# **FREDERICK COUNTY PLANNING COMMISSION**

**TITLE:** Adamstown Village, Section I, Lots 1-8

**FILE NUMBER:** S-678, AP 13951 (APFO N/A, FRO 13962)

**REQUEST:** **Agricultural Cluster Concept Plan Approval**  
The Applicant is requesting Concept Plan approval for an 8-lot Agricultural Cluster subdivision on a 65-acre property.

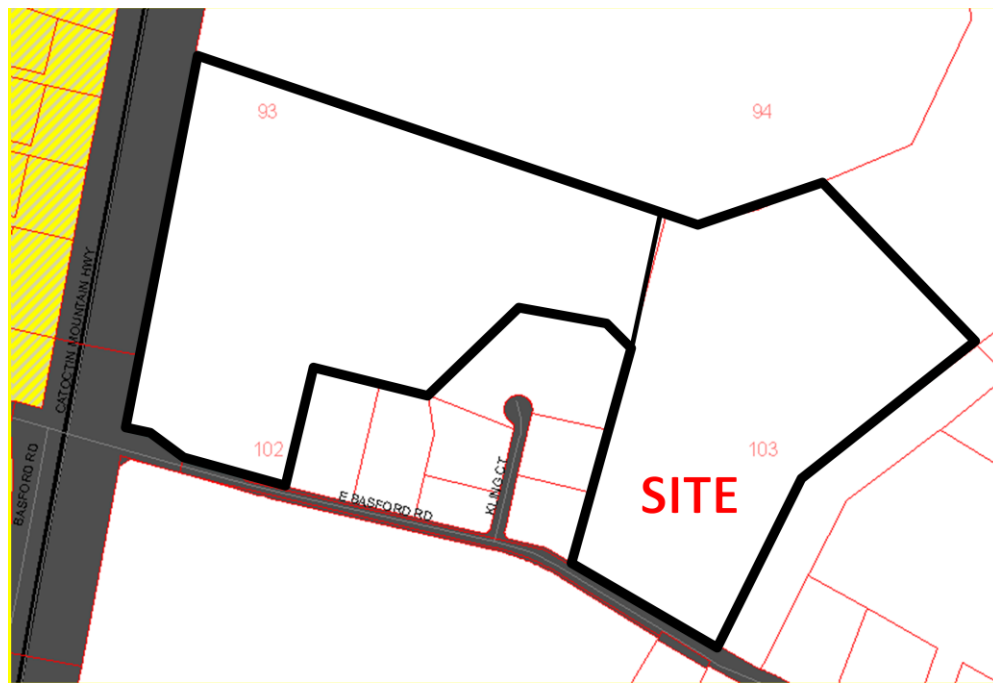
The proposed eight-lot subdivision is situated in the southeast corner of the property, between the existing Adamstown Village subdivision and a Potomac Edison electric transmission line corridor. The entire 65 acre property consists of Class I, II, and III prime agricultural soils (a list of these soils is provided on the Concept Plan). The site of the proposed subdivision consists of class II soils. However, the only other area of the property with adequate road frontage for subdivision is at the intersection of US 15 and consists of class I soils. Class I soils are the highest quality soils. Therefore, the subdivision is situated to minimize the development of the higher classified soils in an attempt to meet these regulations. The proposed subdivision location is adjacent to existing residential development.

The subject property has an Agricultural/Rural Comprehensive Plan land use designation (see map above). The proposed land use and subdivision design complies with the Comprehensive Plan and will meet Zoning Ordinance requirements if the FcPc determines that the design meets the Ag Cluster provisions.
